## V2500-A5/D5 SERIES PROPULSION SYSTEM NON-MODIFICATION SERVICE BULLETIN

This document transmits the Revision 2 of Non-Modification Service Bulletin V2500-ENG-72-0585.

# V2500-ENG-72-0585

NON-MODIFICATION SERVICE BULLETIN – ENGINE – HP COMPRESSOR BLADES - INSPECTION  
OF THE HPC STAGE 5 ROTOR BLADE RETAINING PLATE SLOT

Figure 1 – Appearance of Abrupt Transition

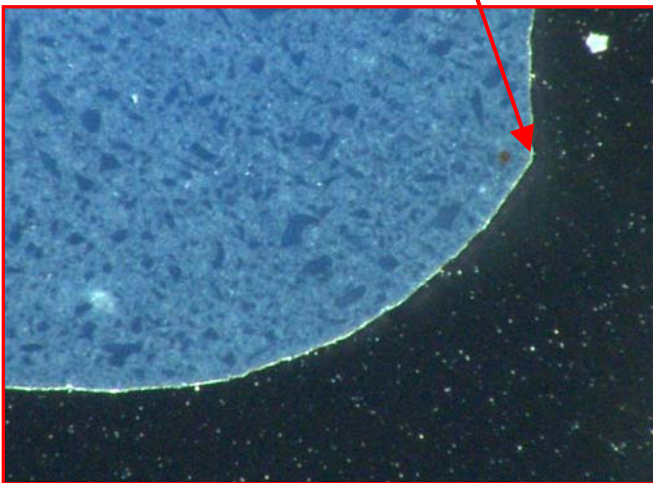
- (a) Visually examine the retaining plate slot of the HPC stage 5 rotor blade with minimum 10x magnification.
- (b) Examine the Stage 5 Rotor Blade retaining plate slots for cracks.
- (c) Compare each blade to Figure 1 and Figure 2.
- (d) Reject any HP compressor stage 5 rotor blade with a crack or an abrupt transition in accordance with Figure 1.
- (e) If any blade is found cracked in the retaining plate slot, reject the whole set of HPC stage 5 rotor blades.
- (f) Quarantine the whole set of rejected HPC stage 5 blades and inform your local IAE office.

Figure 5 – Area Allocated for Part Marking (N 585)

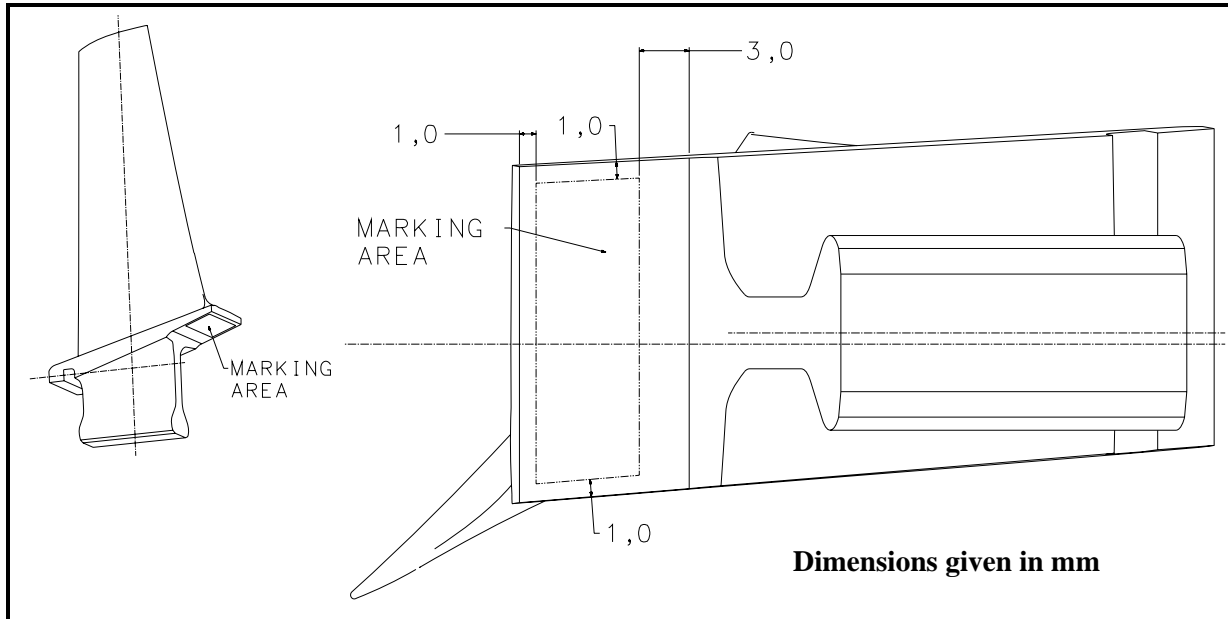
- (b) Identify the inspected HP compressor stage 5 blades (Refer to the Standard Practices/Processes Manual, Chapter 70-09-00).
- (c) Vibro peen 'N 585' on each HPC stage 5 rotor blade that passed inspection in 3.E(1), 3.E.(2) and 3.E.(3) in allocated area (Fig.5).

Note: Do not vibro peen outside the marking area.

Note: Any blade marked outside the marking area must be scrapped.
